Government of the Northwest Territories Fort Providence, Kakisa Power Line Review Preliminary Design Report Review

2020-03-04	0	Approved for Use	D. Zhang J. Sabrina S. Maleki	V. Pathirana	D. Almanza	
Date	Rev.	Status	Prepared By	Checked By	Approved By	Approved By
HATCH						Client

Figure 4-1: Conceptual SLD Proposed Expansion

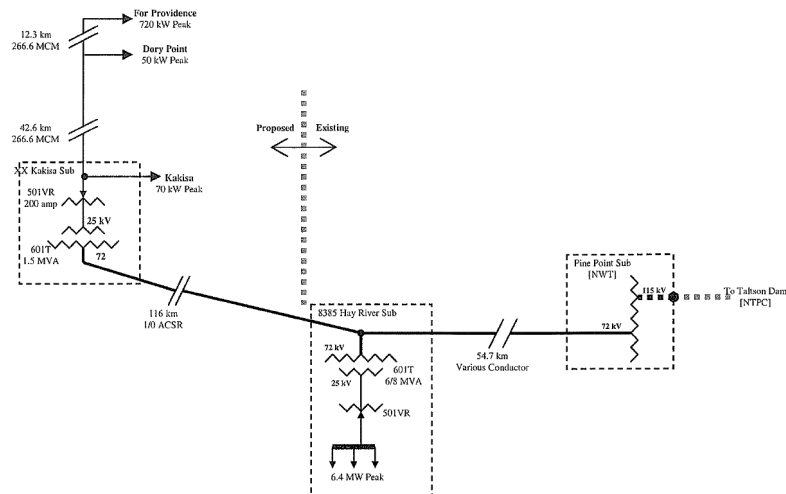
Hatch comment: The 25 kV conductor model is different with what mentioned earlier in the report. This may affect the results. Further investigation is required.

Figure 4-1: System Voltage Profile During the No Load Case

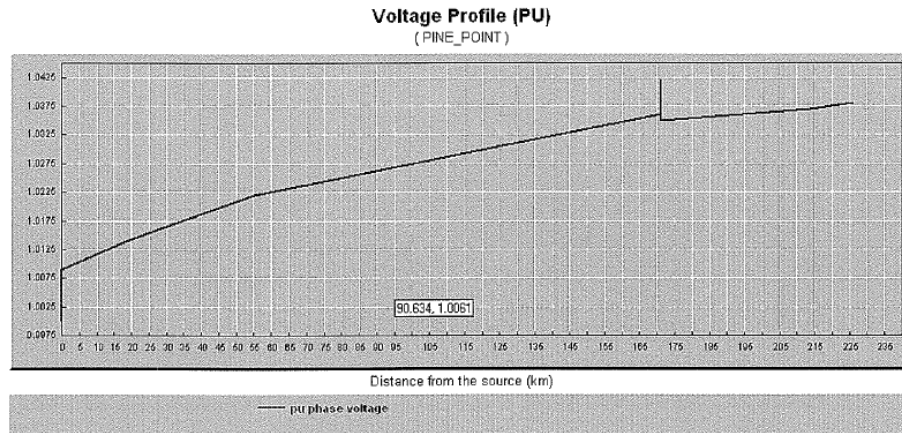
Hatch opinion is that No critical voltage issue is observed for system voltages (the voltage variations are within 5%) during the no load and maximum loading scenario.

Although the results show no concern regarding the system voltage profile, the voltage level and the short circuit level at the Pine Point Sub is not provided which can affect the results and may justify the need for reactive power compensation.

Figure 4-3: System Frequency Scan With the New System Extension

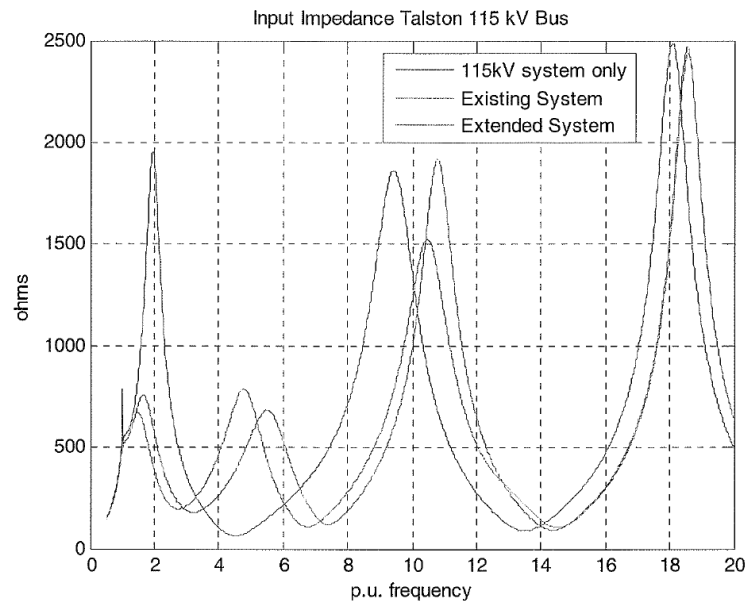
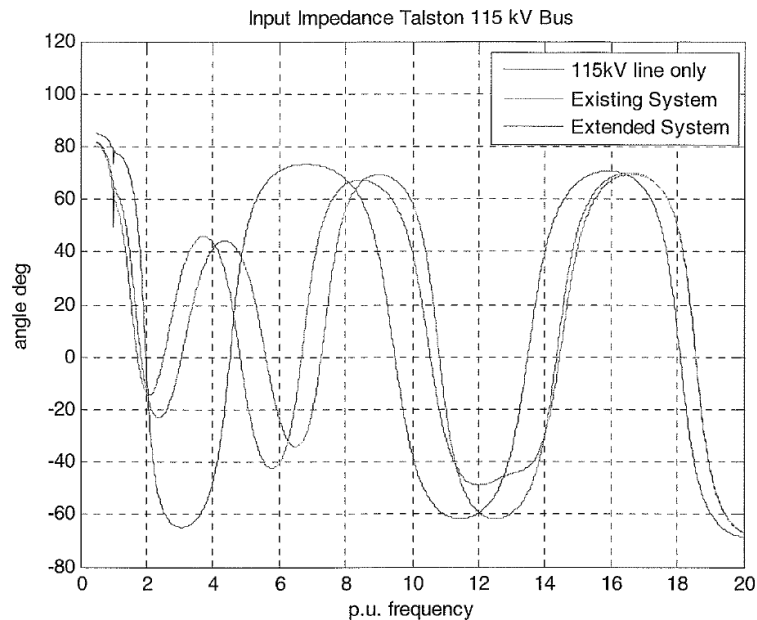
- **Hatch Comment:** Another system impedance scan is required at Kakisa transformer station for both series and parallel impedance scan cases.

Please provide the reference for suggested safe margin of 6 Hz between the natural peak and an even harmonic.

Figure 4-5: Voltage at Hay River Point During the 72 kV Line Energization

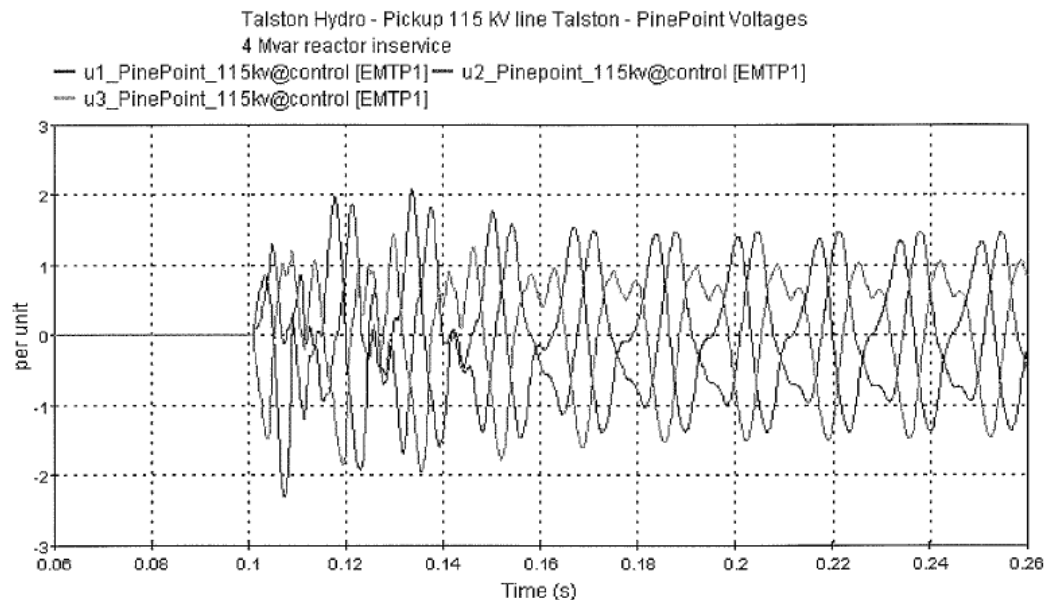
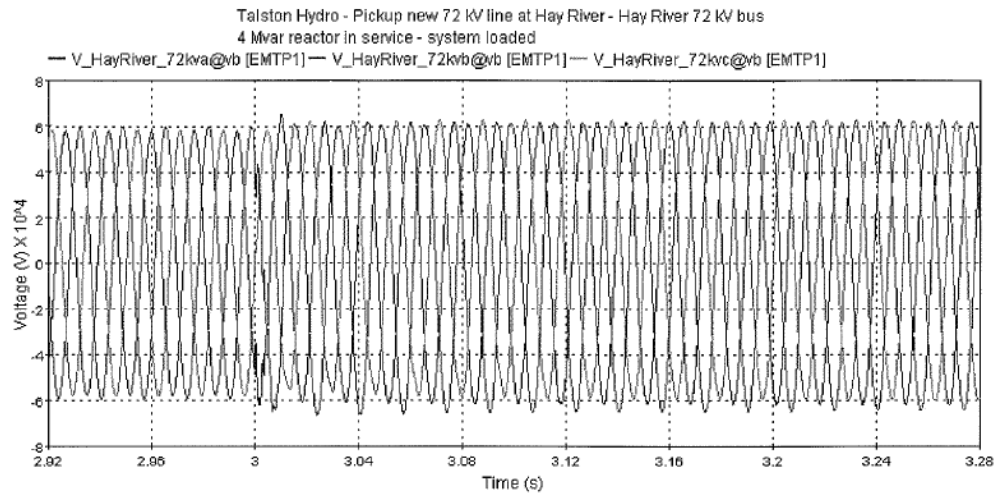
Hatch Comment: Although it is shown that the energization of 72 kV line does introduce significant harmonics on the system voltage, it is recommended to test the energization of 115 kV/72 kV and 72 kV/25 kV transformers.

The report also indicates the TOV at 25 kV bus at Kakisa station which could not be fully compensated by the generator exciter action. The need for 2.5 MVar additional reactive power compensation is determined. This can add complexity to protection and coordination. Additional studies are required to investigate the effect of 2.5 MVar compensation.

Figure 4-6: Effect of Reactor Drop on Selected Buses

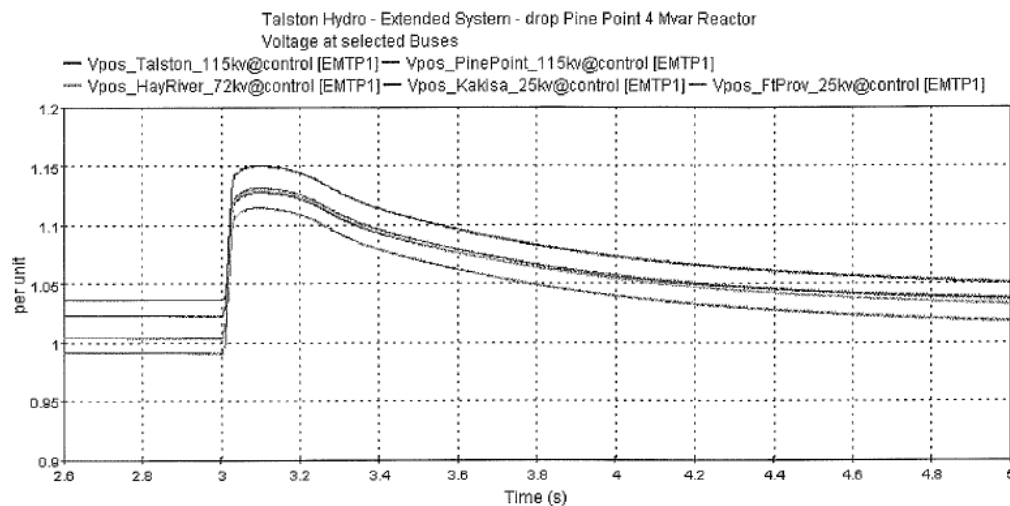
Hatch Comment: According to this results, since the system is very sensitive to contingencies, further investigation on required reactive power compensation is required.
